Public Comments (2025)

AURORA AIRPORT MASTER PLAN

All emails, letters, calls outside of meetings are included in this document for 2025 only; other years are included in separate documents to minimize the document size/length. PAC meeting conversations and questions, as well as emails sent specifically regarding the meetings can be found in the PAC meeting summaries. Comments during Public Open Houses can be found in the Open House summaries.

FIGURE A-1

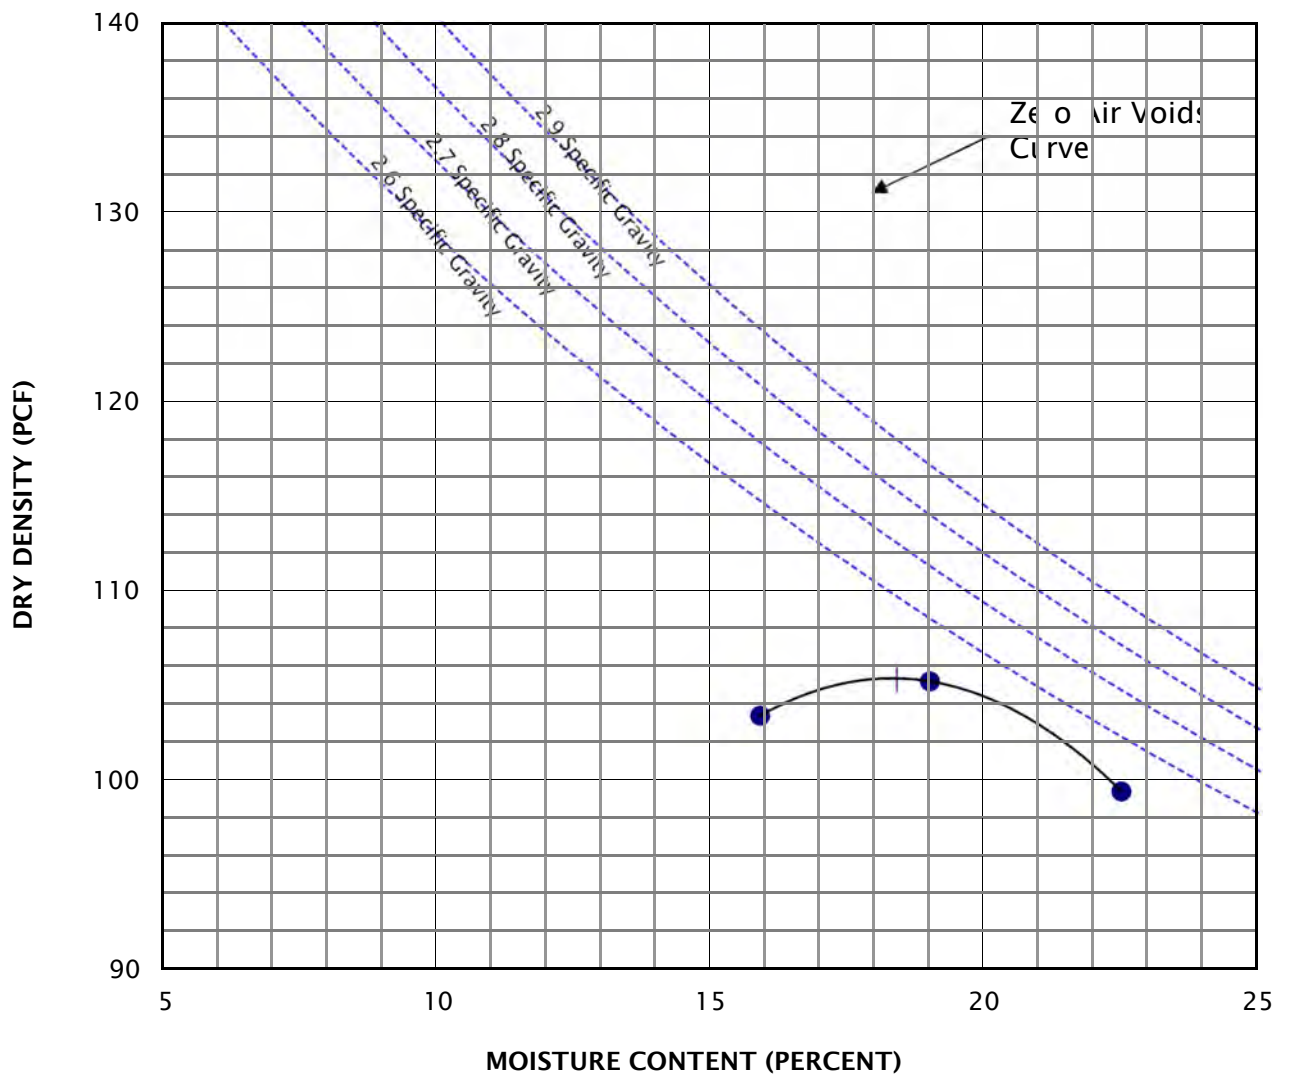
- Report figures
 - o Figure A-1: graphic does not show up in the provided pdf
 - o Figure A-2: graphic does not show up in the provided pdf
- "Such stringent compaction is not permitted in the soil cover of drain fields"
 - o Where does this statement come from?
